Proposal for amendment of ECE R13: Improved HGV brake compatibility

Danish Transport Authority

72nd GRRF, 20-24 February 2012

DIAGRAM 4

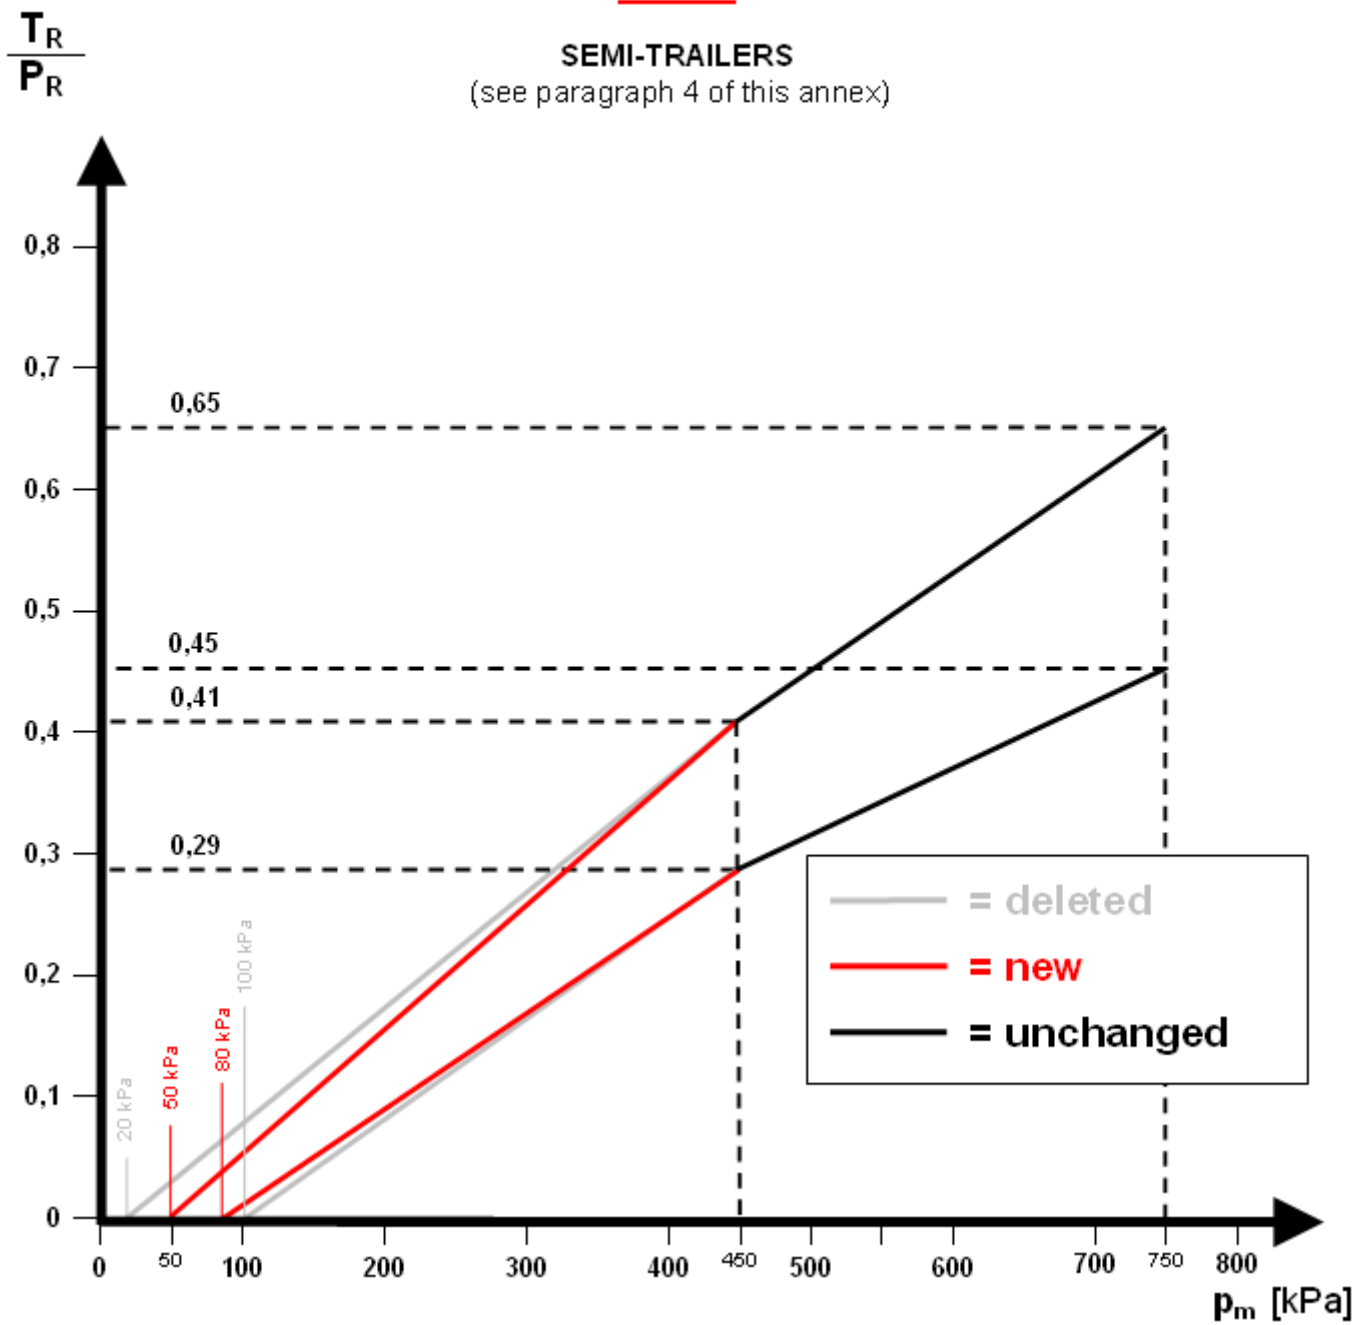
2. Test connection in control line
3. Compatibility diagrams (annex 10) narrowed at low pm pressures and apply at all load conditions at
 $p_m < 200 \text{ kPa}$

Correction factors " K_v " and K_c " to diagram 4, semi-trailers, are simplified in line with simplification of diagram 2 and 3:

1. Only "laden" corridors and corresponding "laden" K-factor apply
2. For load conditions other than fully laden, corridors apply only up to 200 kPa (2 bar)
